SI B63 02 19
Lights

RECALL CAMPAIGN 19V-074: REAR TAIL LIGHT

This Service Information bulletin replaces SI B63 02 19 **dated February 2019**

F48 (X1 SAV)

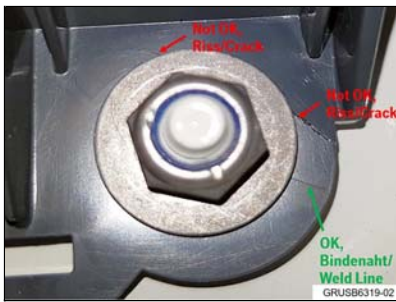
2. **Before** removing the tail light mounting nuts, carefully inspect the tail light mounting areas shown to the left for signs of cracking.

Note: Casting lines in the plastic as shown to the left are not a defect.

UPDATE! Ensure the tail lights are only replaced in case of cracking or oil contamination.

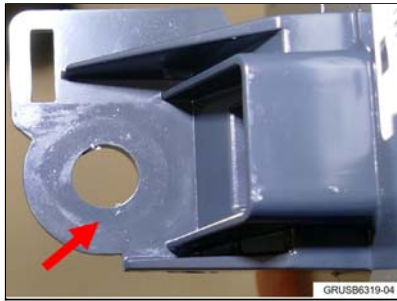
Inspect the mounting tabs of the tail lights for signs of oil residue. Examples of oil residue on the

mounting tabs can be seen to the left. All 3 photos to the left show indications of oil residue and are **NOT OK**.

Warning: The tail light mounting nuts may be contaminated and can **NOT** be reused. Reusing a contaminated mounting nut will cause the new tail light to fail.

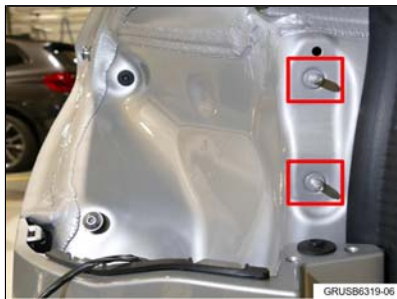
6. With the rear lights removed from the vehicle, the tail light mounting studs and vehicle body **MUST** be cleaned to remove potential residual manufacturing oil.

Using an 80% ethanol/20% water mixture on a clean cloth, clean the mounting studs and body area shown to the left.

Warning: 80% Ethanol/ 20% water is the only suitable cleaning solution that is safe for the vehicle body and tail lights. Do **NOT** use any alternative cleaning solution.
